**REPORT TO CORE AREA WASTEWATER TREATMENT PROJECT BOARD
MEETING OF FRIDAY, APRIL 12, 2019**

SUBJECT Refinement of Project Scope

Figure 1: The four Project scope components remaining to be procured (Currie Pump Station upgrades; Trent Forcemain extension; East Coast Interceptor twinning; Currie Forcemain twinning): all are proposed additions to the eastern branch of the CRD's core area conveyance system

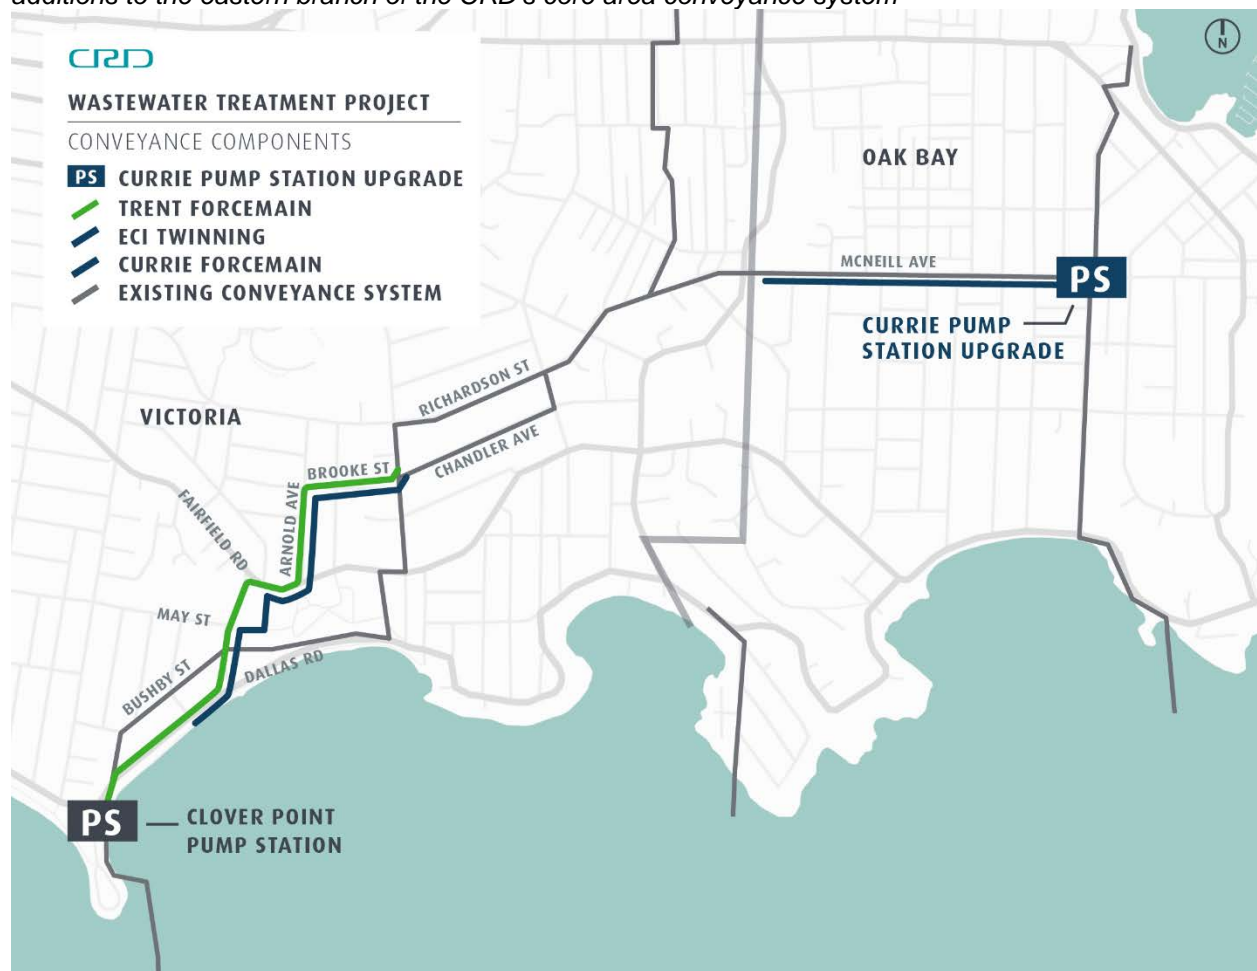
KWL have built the model and the results show that there is no benefit to building three of the remaining Project components, and only one of the remaining components (extension of the Trent Forcemain) is required to meet the Project's goal of meeting regulations.

The Project team are therefore seeking the Project Board's approval to refine the Project scope by removing three components of the conveyance system as they do not provide a benefit to the CRD's residents and businesses, and are not required to meet the Project's goals.

goals, and would provide no benefit to the CRD's residents and businesses, the Project team are seeking the Project Board's approval to remove the following three components from the scope of the Project:

- a) Upgrades to the Currie Pump Station;
- b) Twinning of the Currie Forcemain; and
- c) Twinning of the East Coast Interceptor.

1. The Project's scope, as defined in the business case (Appendix 1 to the Project Board's September 7, 2016 report entitled 'Final Report'), be refined to remove the following components from it:
 - (a) Upgrades to the Currie Pump Station;
 - (b) Twinning of the Currie Forcemain; and
 - (c) Twinning of the East Coast Interceptor.
2. This report be forwarded to the Core Area Liquid Waste Management Committee and CRD Board for information.
